Re: 221 Danbury Rd
Proposed Child Day Care Center
Response to Staff Comments

VHB is pleased to offer the following responses to the emailed comments received on 12/30/2022 by Daphne White and engineering comments from Frank Smeriglio dated 1/4/2023:

Proposed Re-Tenancing
and Playground for
Guidepost Montessori
Child Day Care Center

Drawing Title
Landscaping Plan

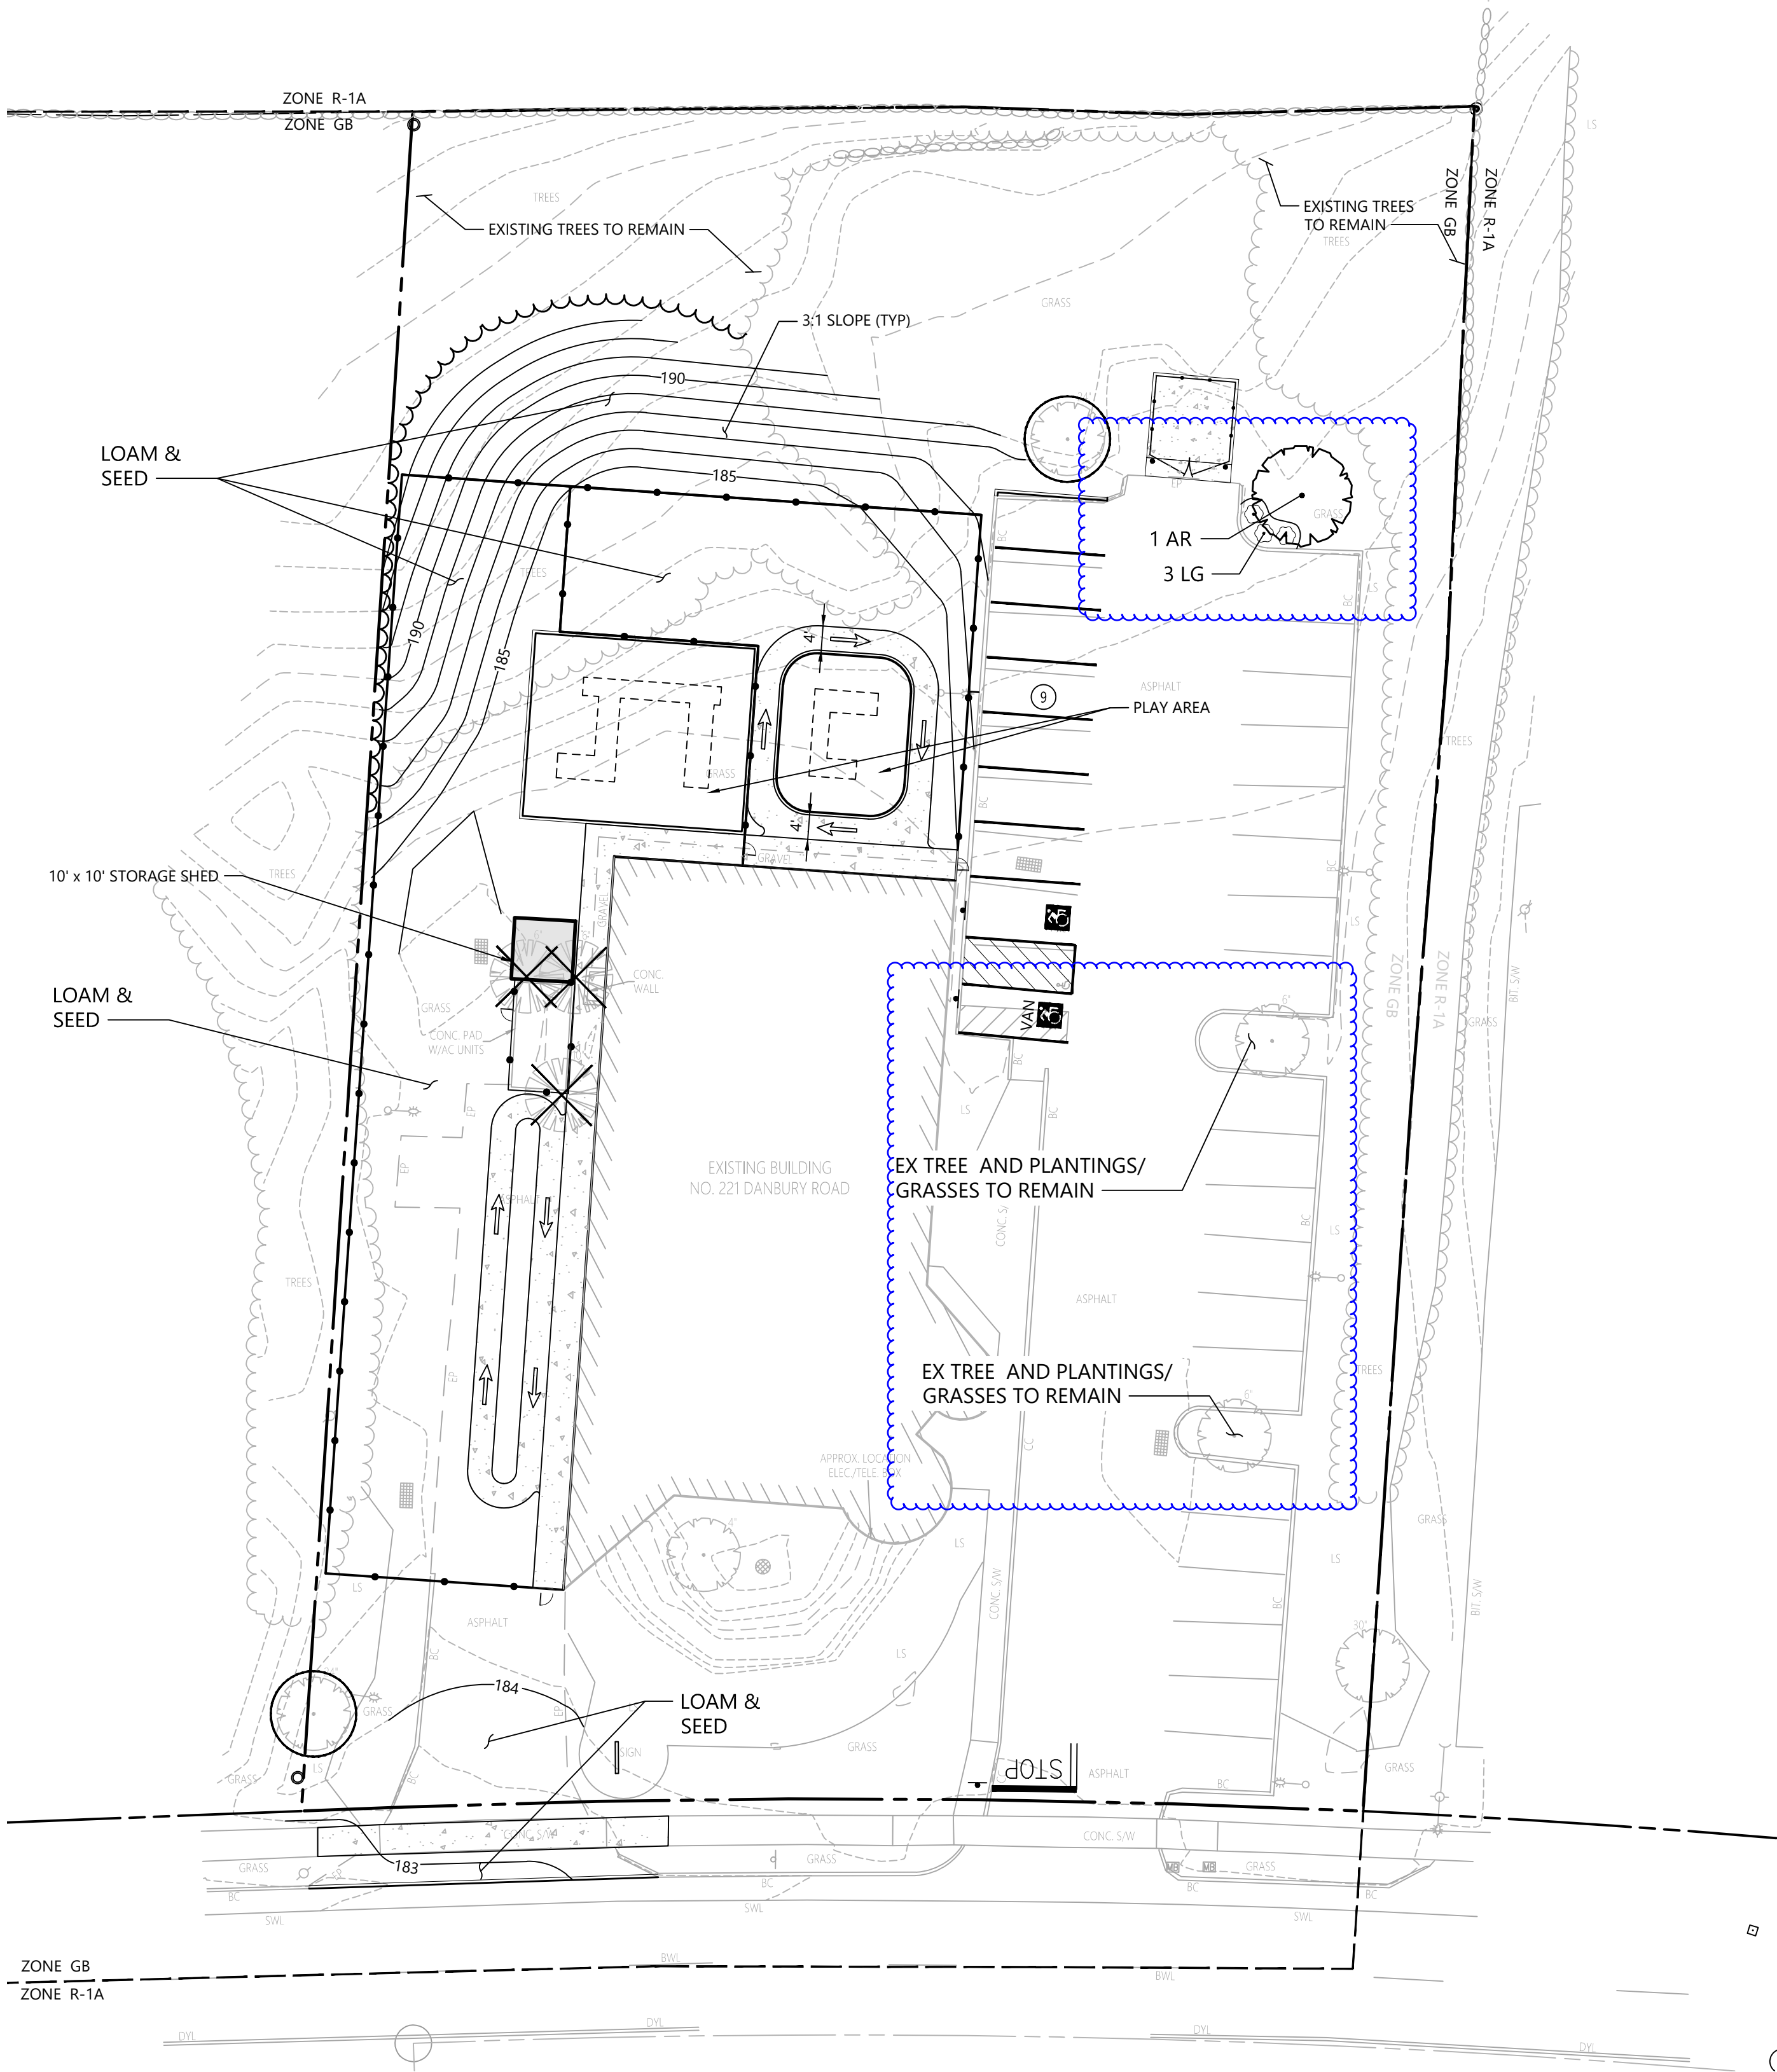
3. Will the existing tree line on the northern property line remain? In addition, has the applicant considered adding additional plantings to the property, including the parking areas, to meet the standards noted in Section 29-8.C.4?

RESPONSE: The applicant is not proposing a new building or parking lot (other than resurfacing/ crack repair), thus the parking lot landscaping is intended to remain. The tree line along the north property line will remain. The applicable regulations of Sec. 29-8.C.4 requires 10% of parking area shall be suitably landscaped, as well as 20 SF of net planting area per parking space (see attached graphic). There is approximately 5,760 SF of parking area and 29 parking spaces, thus 10% and 20 SF per space is 576 SF and 580 SF respectively. There is approximately 700 SF of landscape area proposed in the parking areas, which satisfies both requirements. Since this is an existing parking lot, the landscape islands are not proposed to be changed.

In addition, per Sec. 29-8.C.4.c(2), 1 shade tree and 3 shrubs per 12 parking spaces or major fraction thereof. Therefore, of the 29 provided parking spaces, 3 shade trees and 9 shrubs are required. The Landscape Plan has been updated accordingly and is included with this letter. NOTE: there are 2 existing 6" dia. shade trees (1 in each island) and approx. 18 shrubs/ grasses (9 each) already located in the 2 islands, therefore, 1 more shade tree and 3 more shrubs are proposed for code compliance (see attached photo of existing islands).

Not Approved for Construction
Drawing Title: Grading, Drainage, and Erosion Control Plan

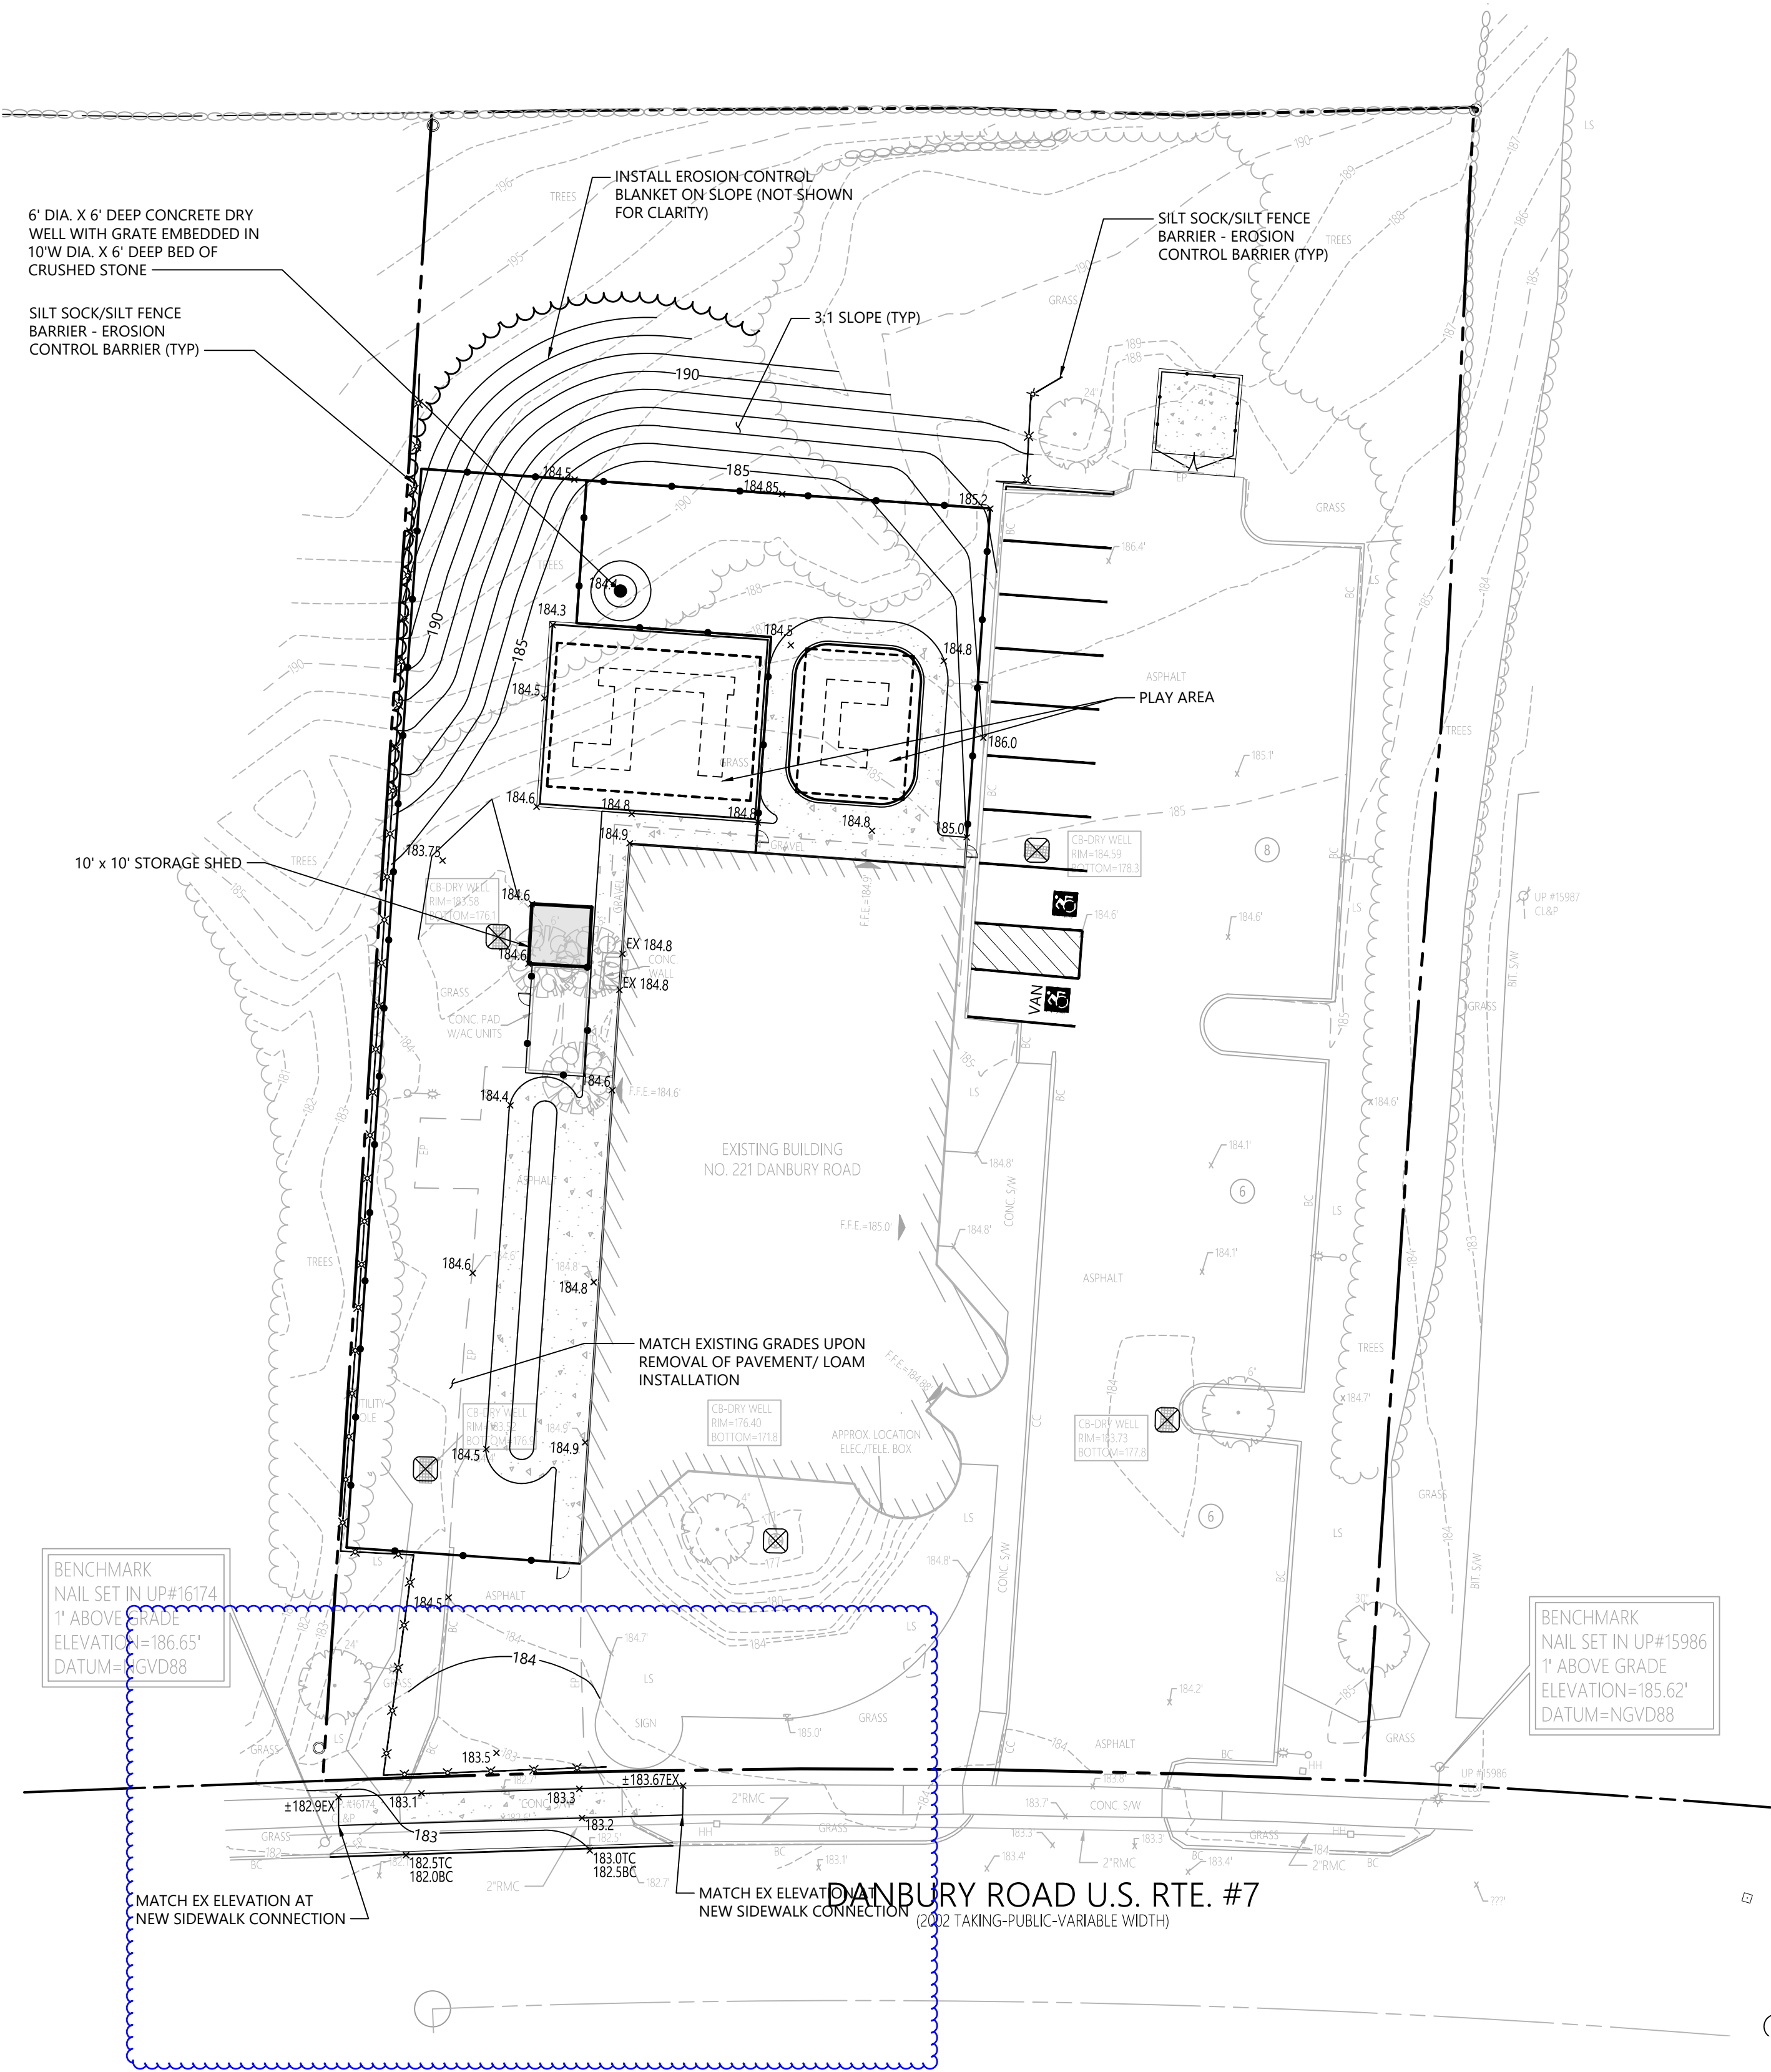
2. Re-Install the sidewalk where the existing driveway is proposed to be removed. The current sidewalk elevations will be too low. Sidewalk details for this portion of the sidewalk shall be in accordance with Town of Wilton sidewalk details and in conjunction with State DOT review.

RESPONSE: see revised Grading plan, attached, which reconstructs and regrades the sidewalk. Currently since the SW is in the ROW, we are showing the CTDOT sidewalk detail, however if you require the Town of Wilton sidewalk detail, we will include.
